HISTORIC AND DESIGN REVIEW COMMISSION

HDRC CASE NO: 2016-185
ADDRESS: 618 E LOCUST
LEGAL DESCRIPTION: NCB 1742 BLK 15 LOT 4
ZONING: R6 H
CITY COUNCIL DIST.: 1
DISTRICT: Tobin Hill Historic District
APPLICANT: Jay Louden
OWNER: Jay Louden
TYPE OF WORK: Rehabilitation, addition and Historic Tax Certification
REQUEST:

The applicant is requesting a Certificate of Appropriateness for approval to perform various rehabilitative measures and construct an addition of approximately 520 square feet. The applicant is also requesting Historic Tax Certification.

① East Elevation HP
3/32" = 1'-0"

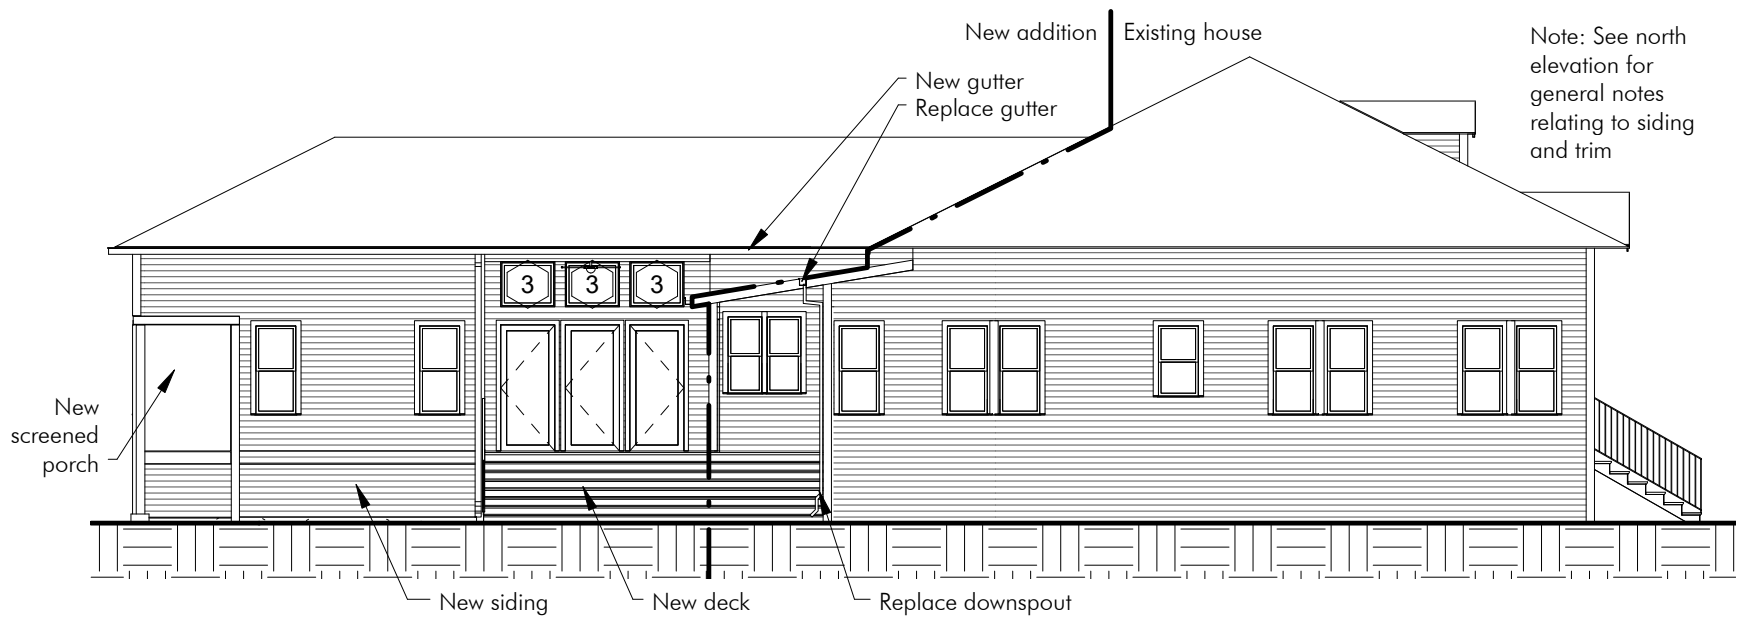
- c. **EXTERIOR MODIFICATIONS** – On the east elevation the applicant has proposed to enlarge an existing window opening from 28 inches in width by 30 inches in height to 52 inches in width by 56 inches in height. The applicant has proposed to install two salvaged windows from the primary historic structure that will be removed during the construction of the rear addition. According to the Guidelines for Exterior Maintenance and Alterations 6.A.i., existing window and door openings should be preserved. While the applicant is modifying with original window opening, staff finds the applicant’s proposal to install salvaged windows appropriate. Additionally, this window’s location on the east façade behind the existing bay obscures its view from the public right of way. Staff recommends the applicant salvage the window that will be removed.

Wall Section HP 701

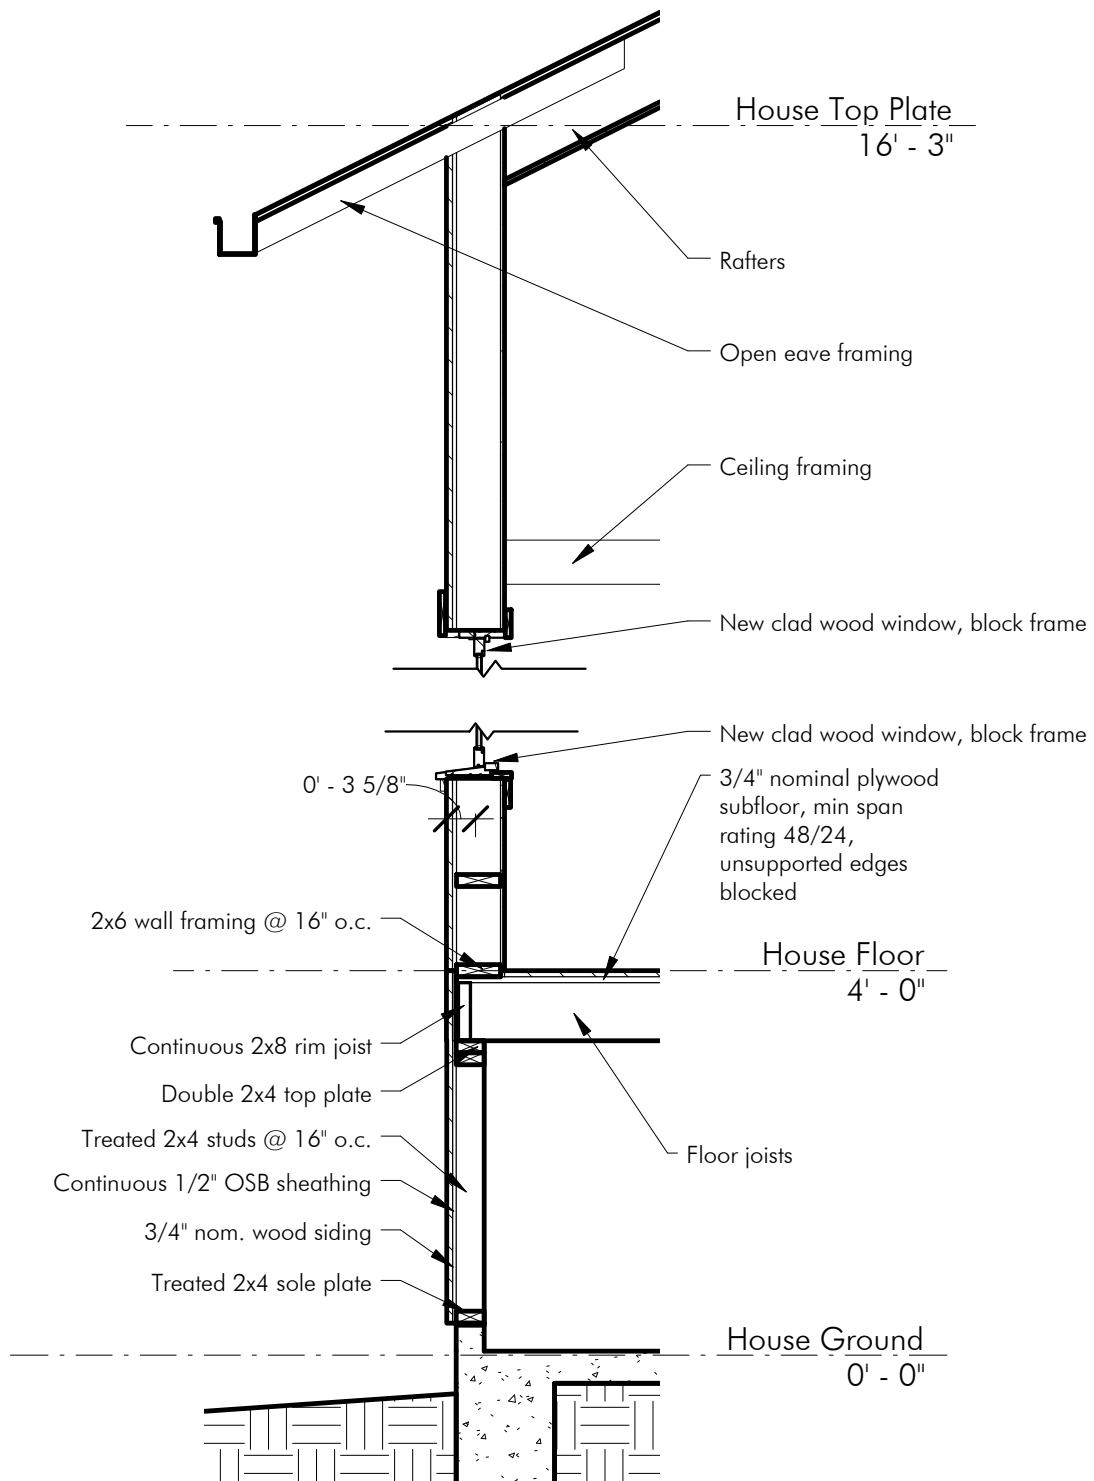
- h. **WINDOWS** – Regarding window fenestration, staff finds that generally the applicant has proposed window openings that are appropriately sized and placed. The applicant has provided staff with a detailed wall section noting the proposed framing of all windows. Staff finds this appropriate.
